Subject: Docket No. 50-206  
Fuel Storage Building  
SEP Topic III-6  
San Onofre Nuclear Generating Station  
Unit 1

RESPONSE TO NRC STAFF QUESTION  
ON  
FUEL STORAGE BUILDING NONLINEAR ANALYSIS  
NOVEMBER 1982

SAN ONOFRE NUCLEAR GENERATING STATION  
UNIT 1

FIGURE 3.1

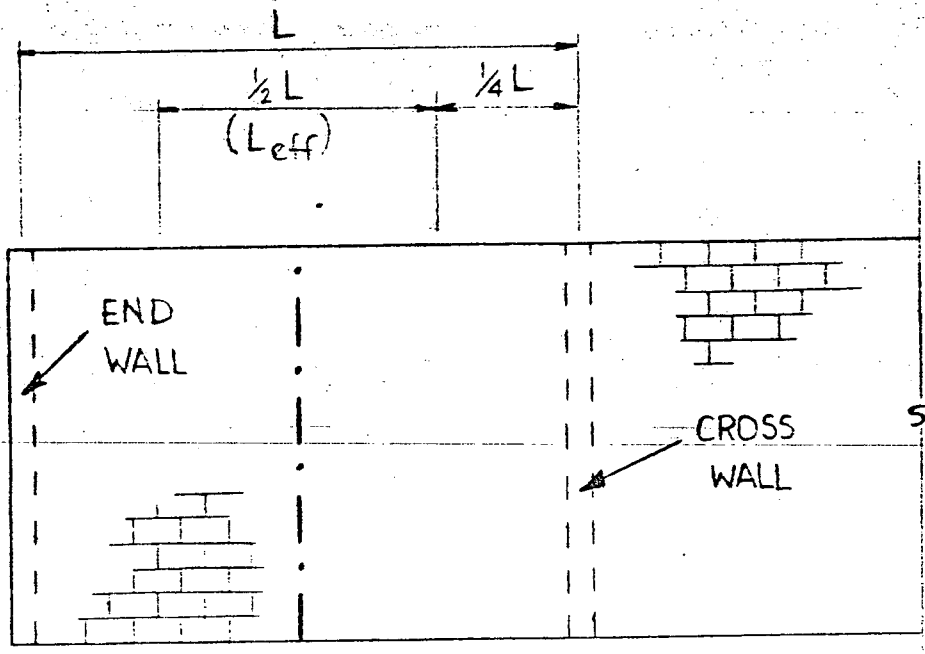
QUESTION 3

What is the definition of the "effective length" of wall in the derivation of the out-of-plane masonry wall properties?

RESPONSE

The effective length is half the distance to the next beam or crosswall to either side of the beam in question. The effective length is therefore merely the tributary length, as shown in Figure 3.1.
